# D-2/1 LATE BACKUP

Notes re variance request C15-2020-0029 coming before BOA this Aug 10, 2020

Subject: Tree Assessment

Address: 1711 Waterston Ave  
Austin, TX 78703

Pecan tree with  
required pruning cuts  
for clearance

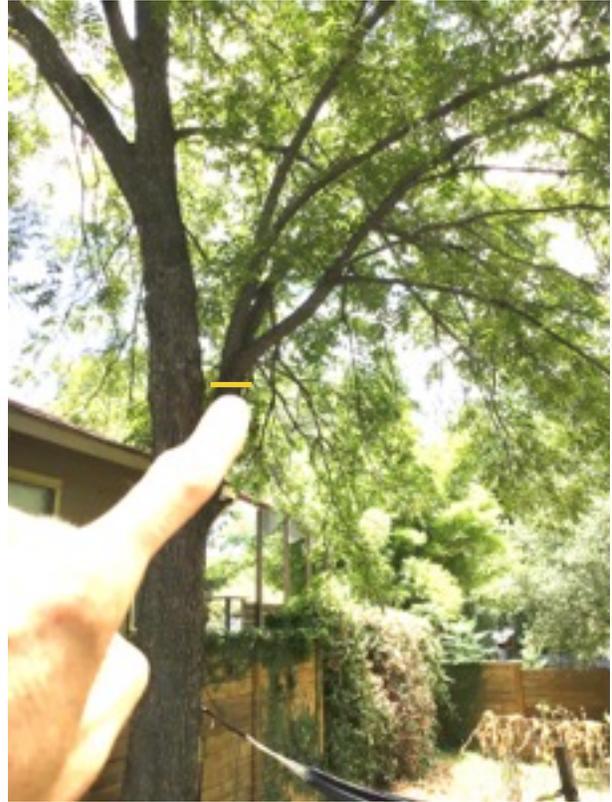
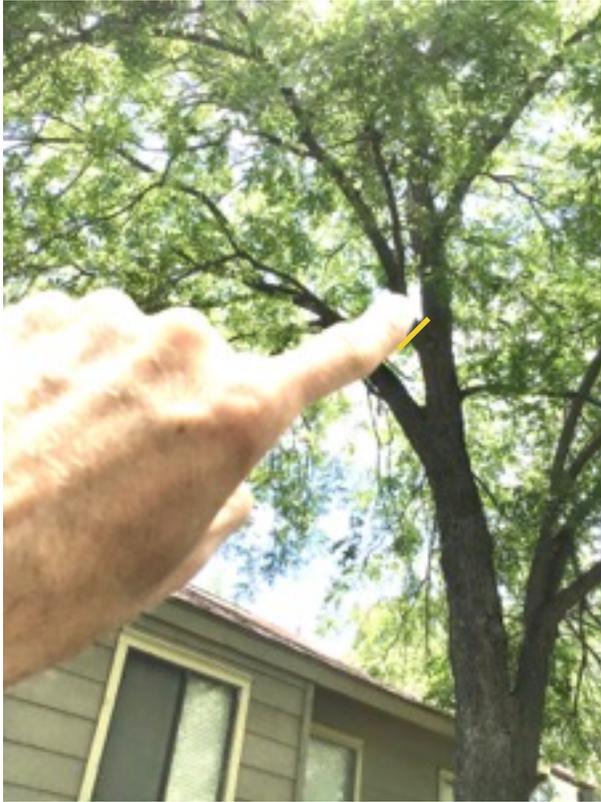
If the 2nd story addition concept is chosen, a large percentage of the canopy will require pruning to accommodate the new structure. As a rule-of-thumb, it is recommended to not remove more than 25% of live foliage from a tree, in a single pruning session. Excessive pruning can stress a tree and cause a tree to decline. Once a tree becomes stressed, it is susceptible to further secondary stressors such as pest and disease. Compounding stressors have the ability to severely impact a tree and threaten the overall health, integrity and mortality of a tree. With regards to the required pruning for a 2nd-story build concept, I recommend maintaining a low home elevation that will not require the tree to be severely pruned.

Any build concept to reduce the amount of impervious cover of the critical root zone is also recommended, as impervious materials and grade changes have the ability to suffocate underlying roots. Practices such as cantilevers and pier-and-beam foundations have less intrusive impacts within the critical root zone and reduce the overall percentage of impervious cover. Excavating with a Airspade tool within the critical root zone will also help to preserve roots and allow building practices that will cause less impacts to the roots and tree. Design the footprint of the new foundation to stay as far out of the critical root zone as able.
